# Enroute Chart Layout 2.0 - Notes

*The most of the following suggestions will be implemented. Some amendments will require a global repositioning of labels, others can be done quickly. In this regard implementation will be executed in two levels:*

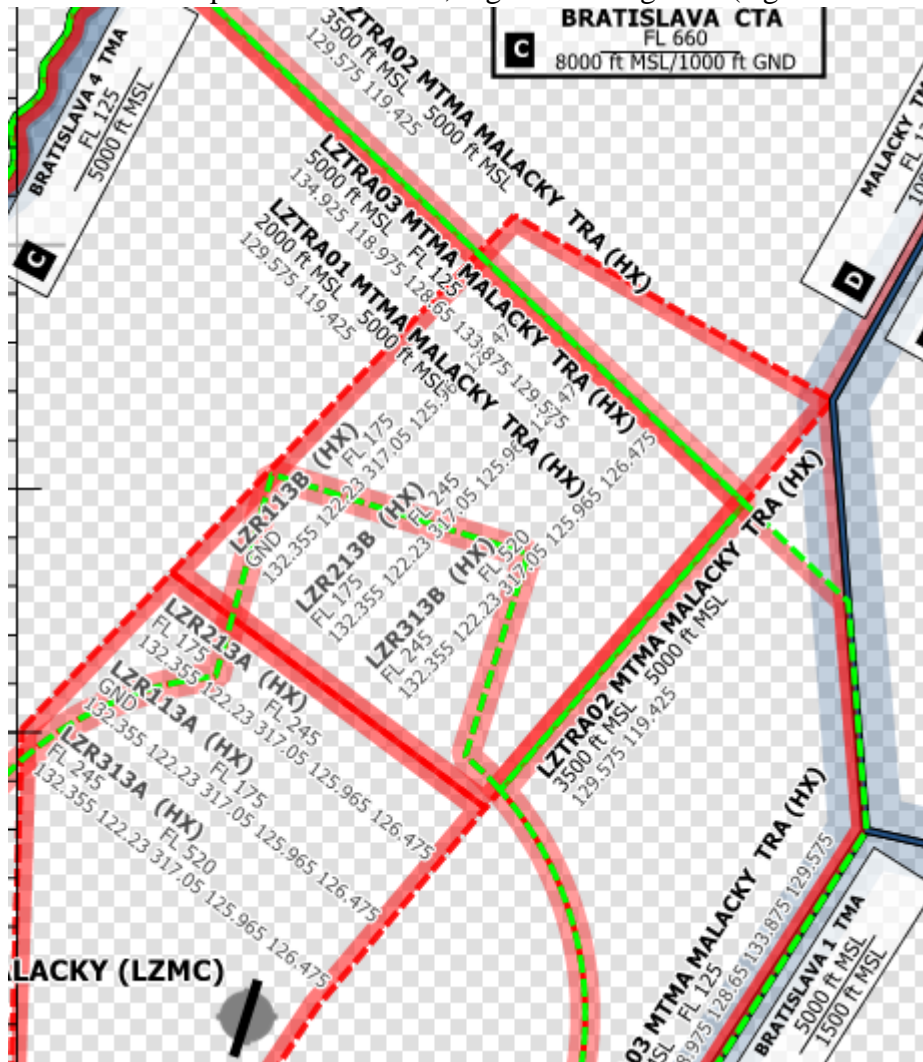
1. Don't show frequencies for TRAs, it gets too congested (e.g. around Bratislava)

2. For restricted, danger and prohibited airspaces, omit the long names (e.g., “LOR-1 Seibersdorf” should only be shown as “LOR-1”). Full names with controlling agency, frequency and hours of activity are shown in table on the map’s edge.

*This can be achieved by using the “Abbreviations” Field – so this is a call to action to contributors to change such airspaces.*

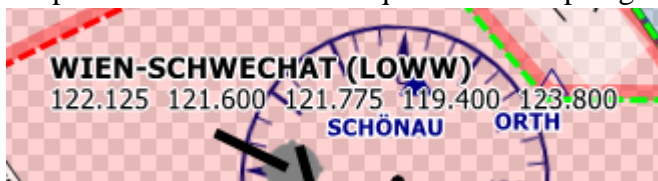
3. Show shaded airspaces for those that reach all the way to the ground and are continuously in effect (similar to CTRs), such as, e.g. LOR-16 (Neusiedler See).
4. Generate a compound label for stacked airspaces with the same lateral limits (similar to LOVV).

*This change can be achieved by inputting airspaces as class layers (provided they have identical lateral boundaries)*

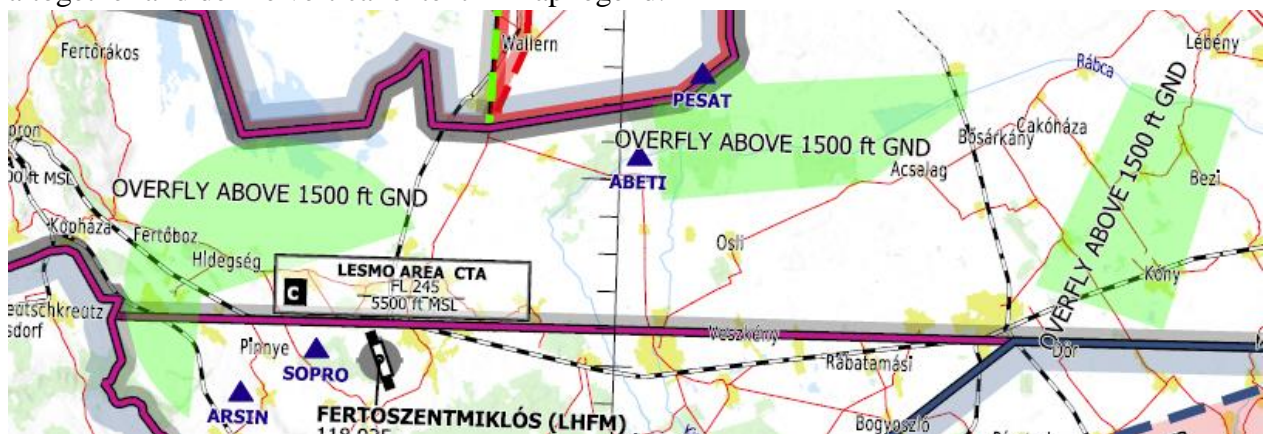
10. When specifying altitudes, omit “ft” and only use MSL or GND to save space.
11. UL- and Gliderports which don’t have an ICAO ID should show their name only (omit the GPS label).  
“TOKORCS (LHTOKO)” should only be “TOKORCS”.
12. For airports, change the style to encode more information visually (refer to US Sectional Carts for reference and ideas):  
grass or asphalt/concrete runway  
Runways greater than 500 m length, runways greater than 2.500 m length  
Military vs. civil use airports  
Abandoned airports  
Fuel availability  
INFO/TWR/ATIS frequencies  
Elevation  
Controlled vs. uncontrolled airport (i.e., radio contact required or not)
13. Here are some suggestions on how to further evolve icons for airports to connote more information and reduce textual clutter.

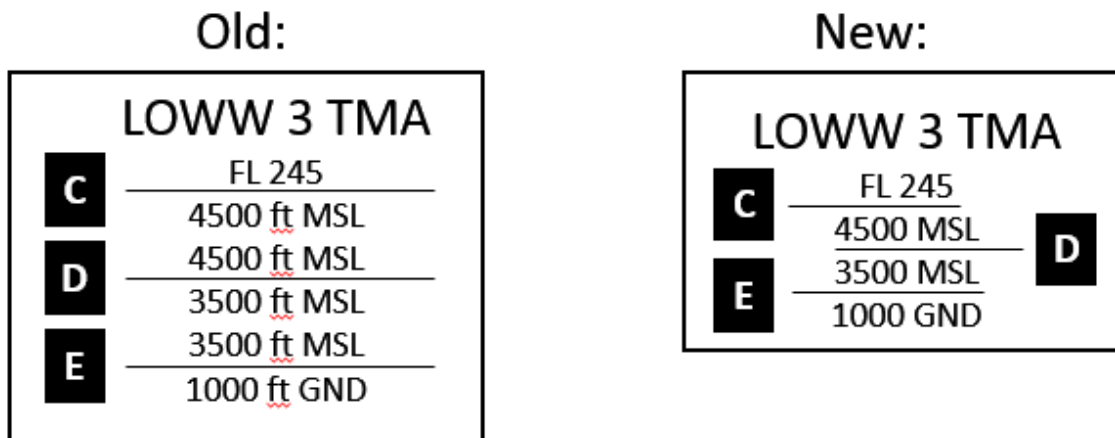
16. When labeling stacked airspaces use this format (omitting ft and repeated altitudes):

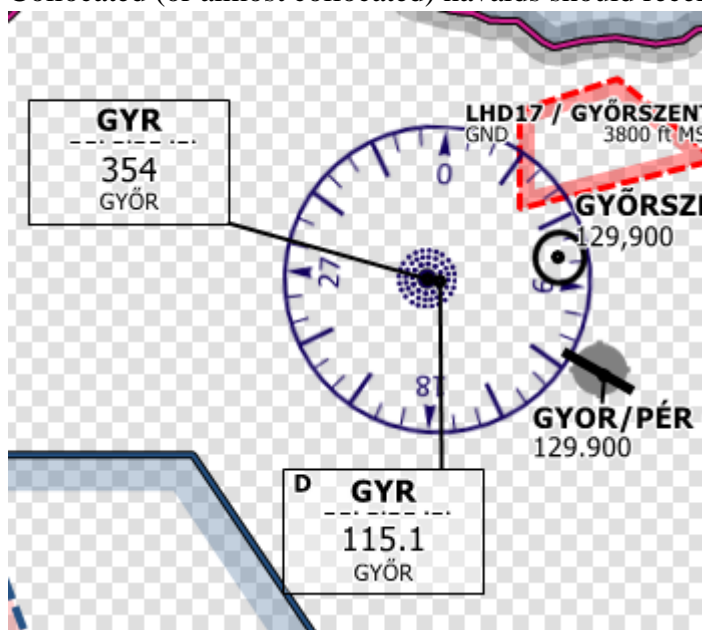
17. Collocated (or almost collocated) navaids should receive a compound label:

V=VOR, D=DME, N=NDB.

*Since this particular case is of rare occurrence, we might postpone the implementation or omit it completely.*

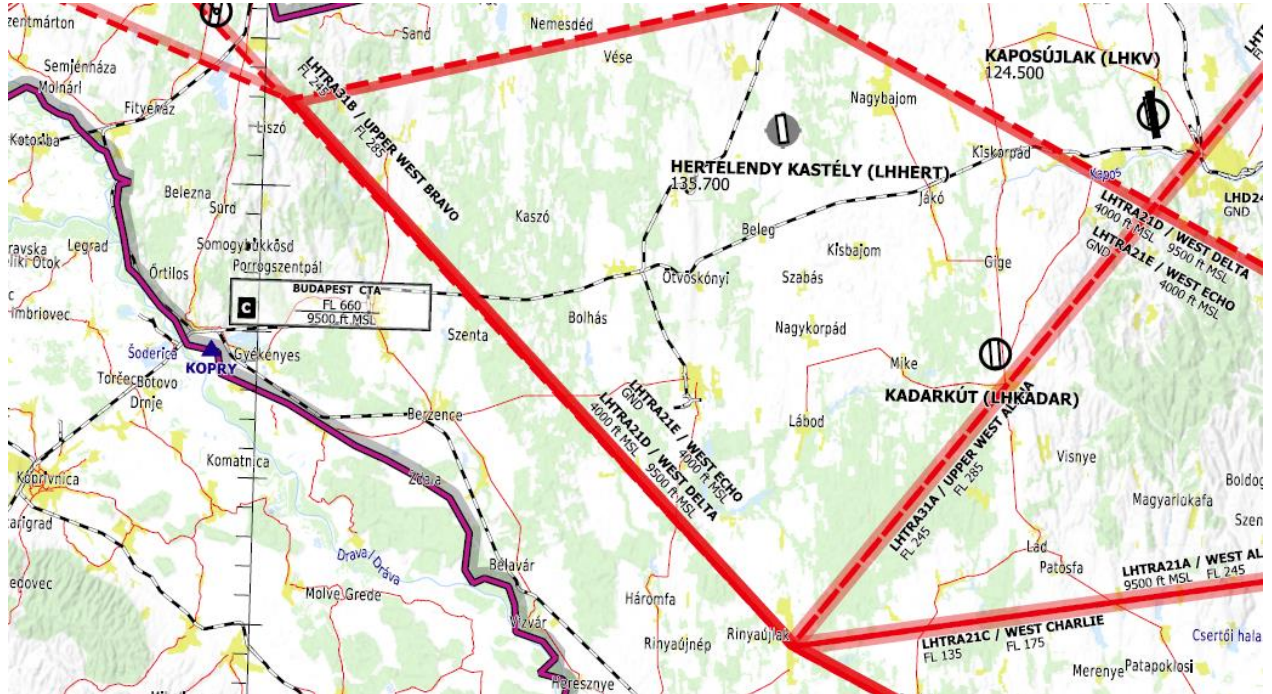
18. Whenever multiple TRA boundaries coincide, the line gets confusing. In the example below, I can discern four different line styles, even though there is only a single type of airspace (TRA).

**This issue has been solved already!**

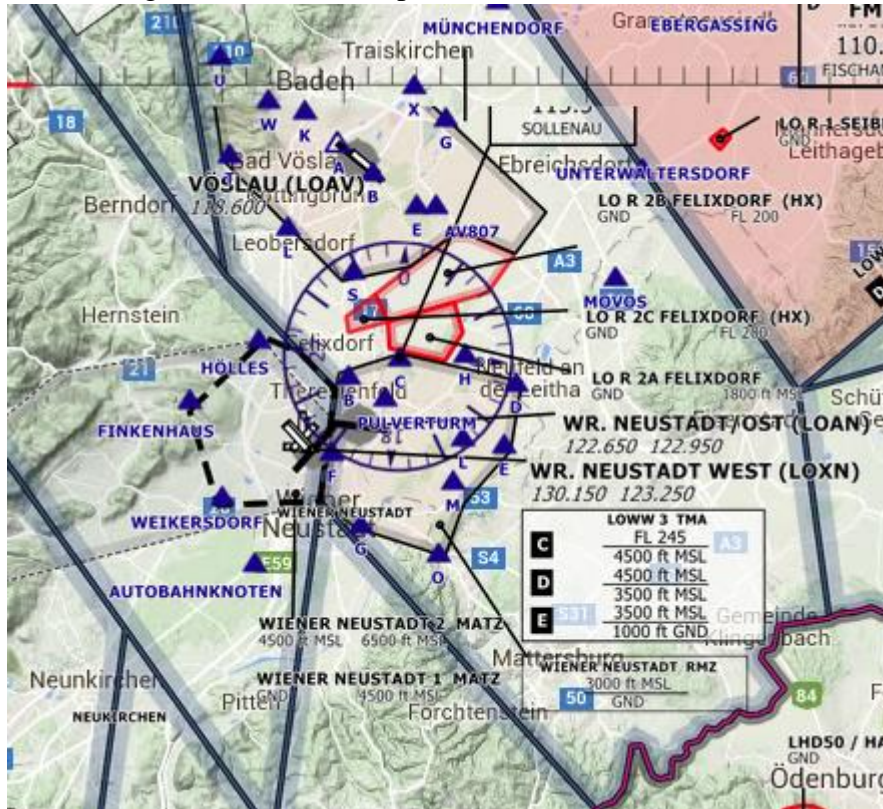
20. Guiding lines between airspaces and their annotations tend to confuse the picture.

Optimize label placement and reduce weight of guiding lines. Also, sometimes there is a large gap between the line and its annotation.
